ADDENDUM No. 1

**Runway 35 Approach Clearing Project
Bid # FY17-805-45**

at the Manchester – Boston Regional Airport

Date: _____ **April 21, 2017** _____

DRAWING NO.
C3.1
SHEET 18 OF 24
REV

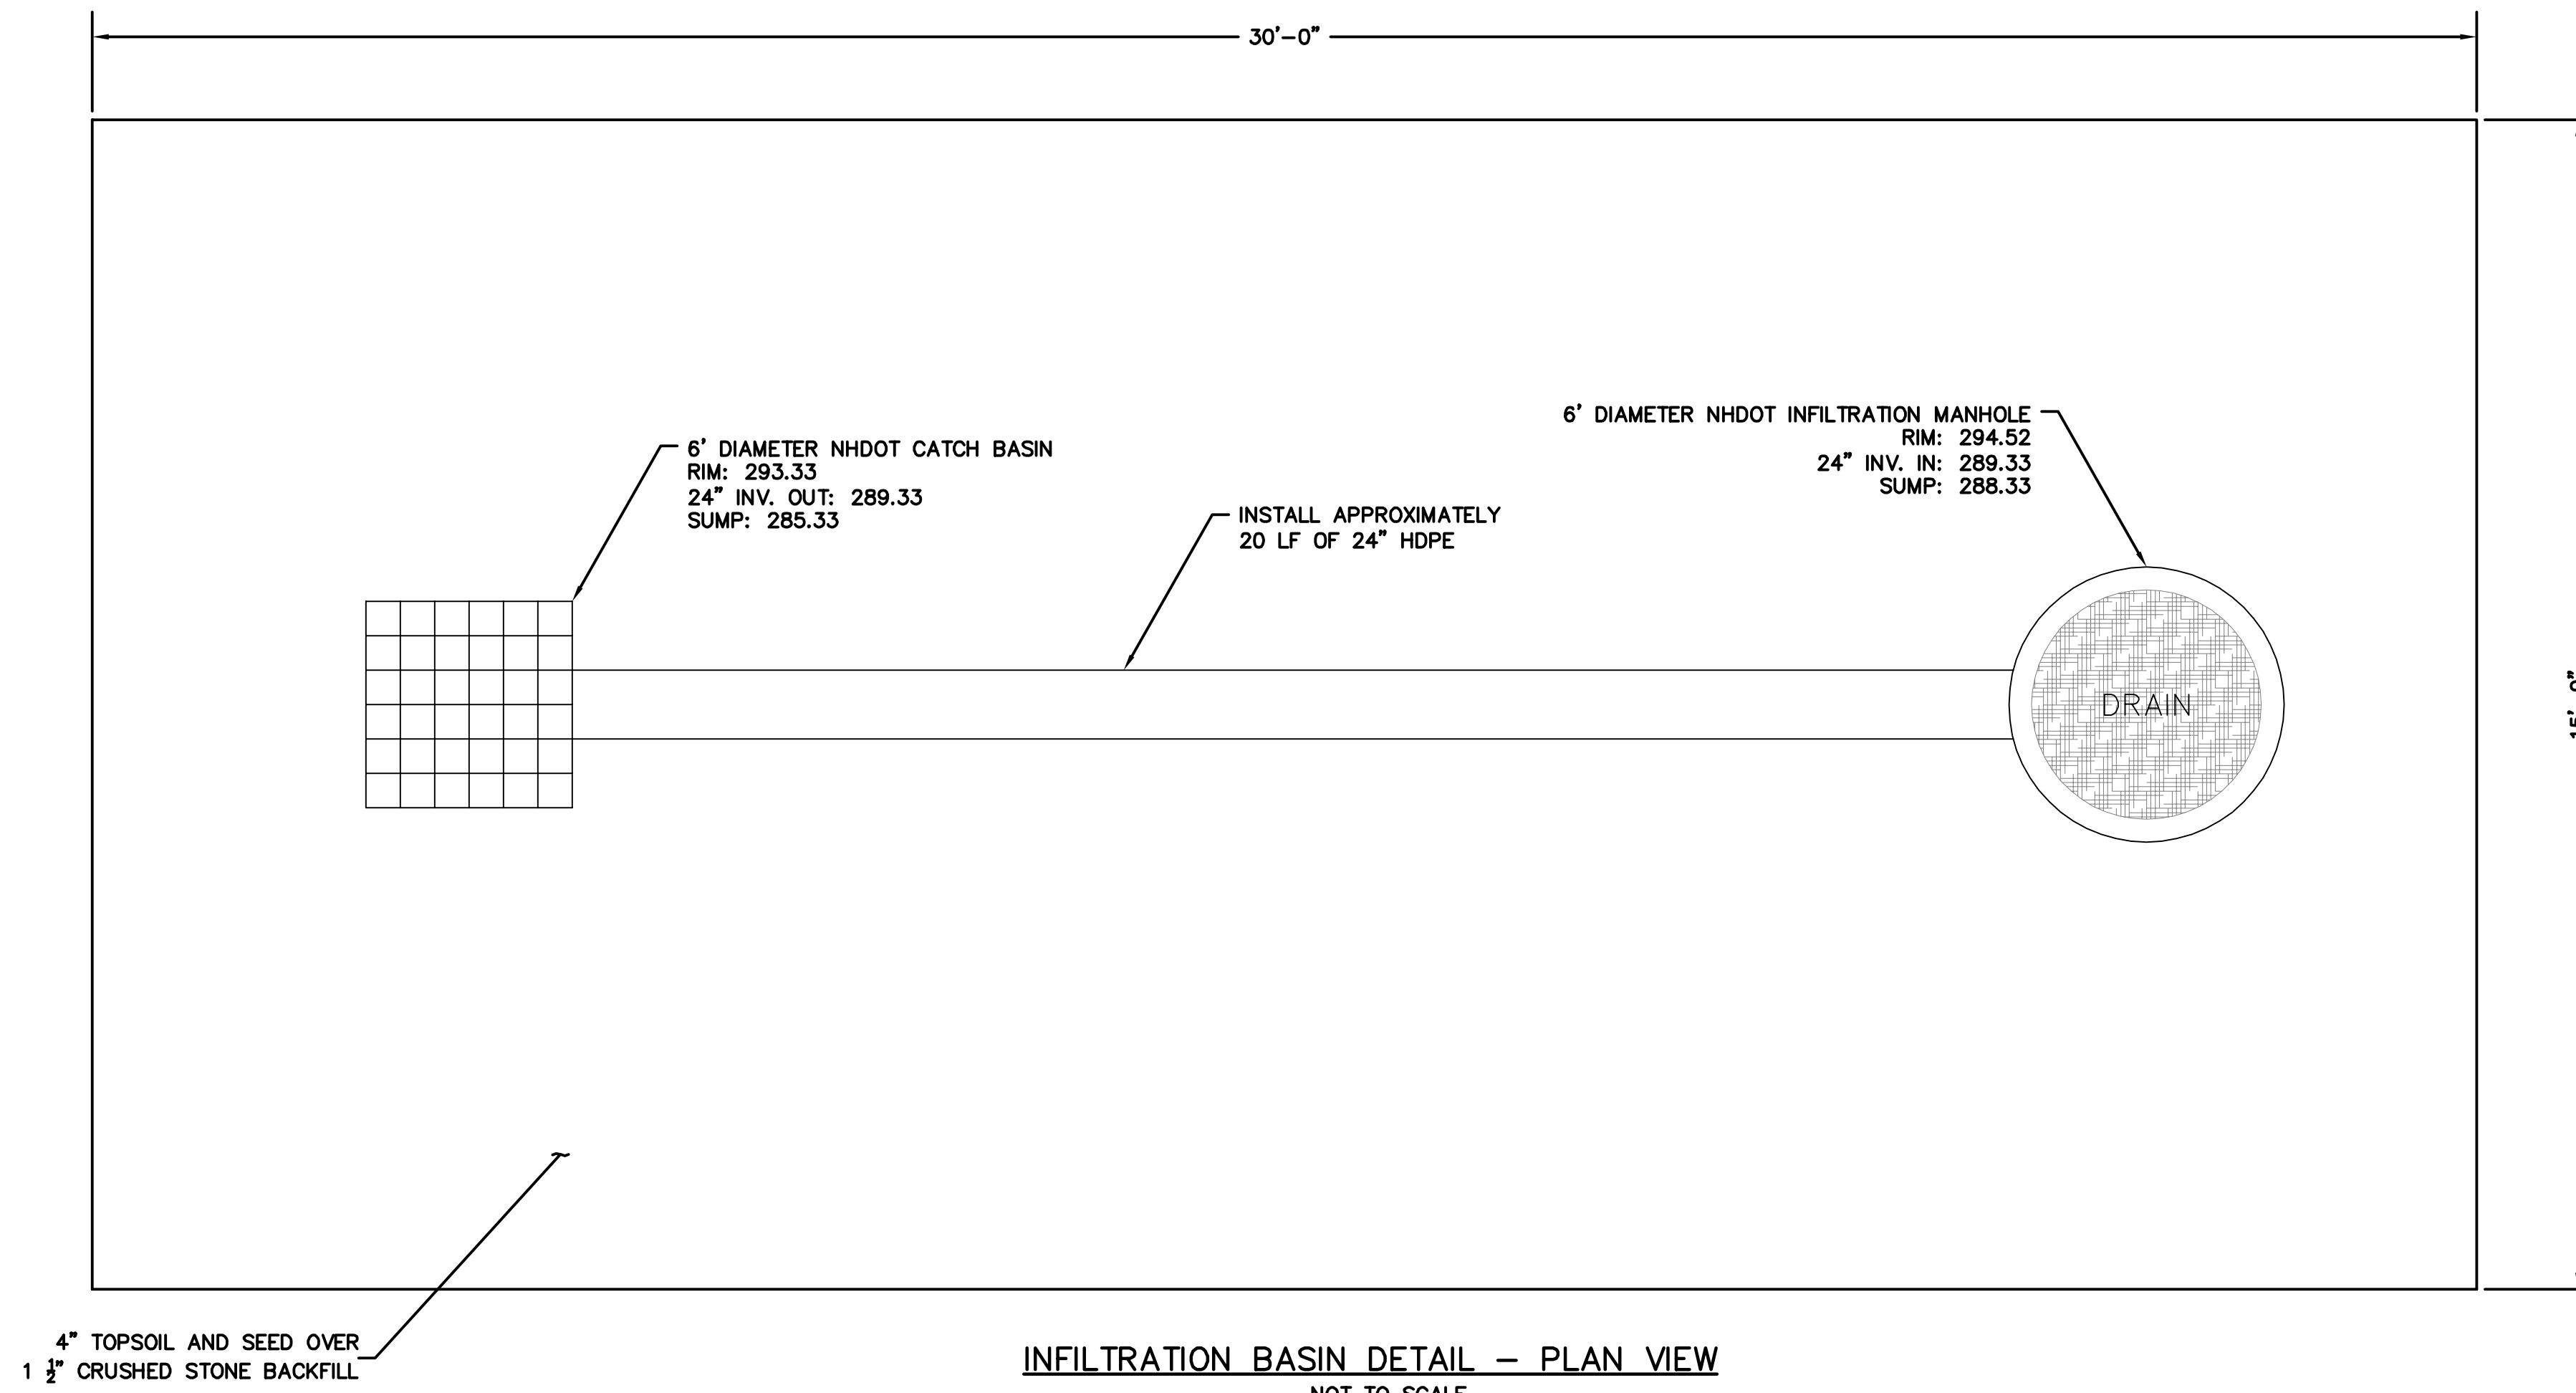
REMOVE Drawing Number C3.1 from the plan set AND REPLACE with attached drawing C3.1. Changes include the addition of an infiltration basin and revised contours in the indicated area.

DRAWING NO.
C3.7
SHEET 24 OF 24

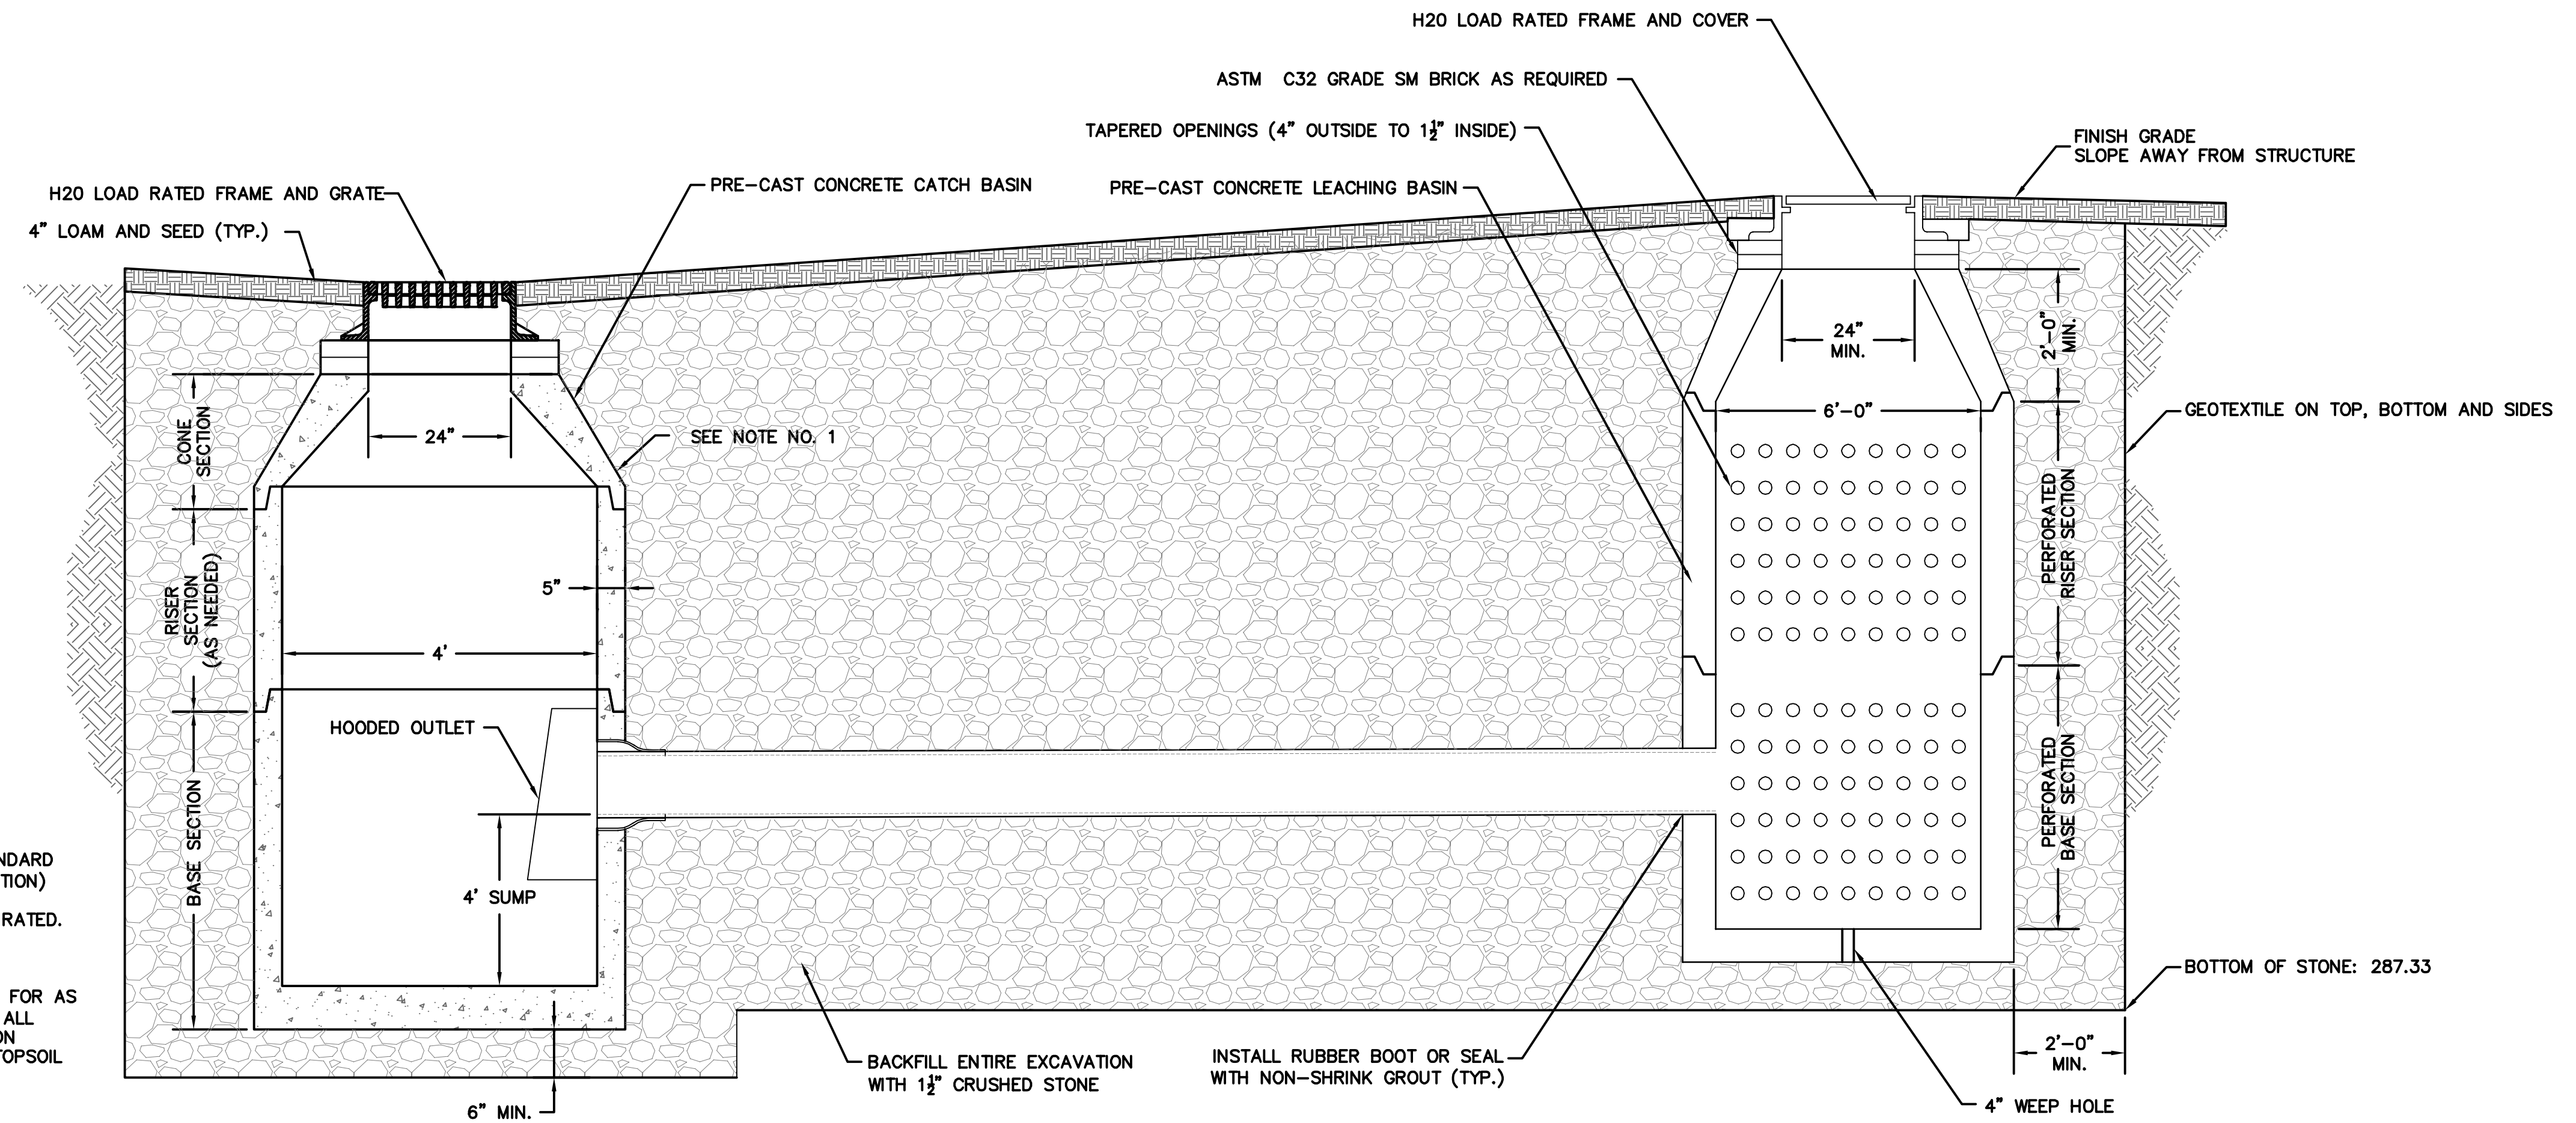
ADD Drawing Number C3.7 to the plan set. This drawing details the infiltration basin added to C3.1.
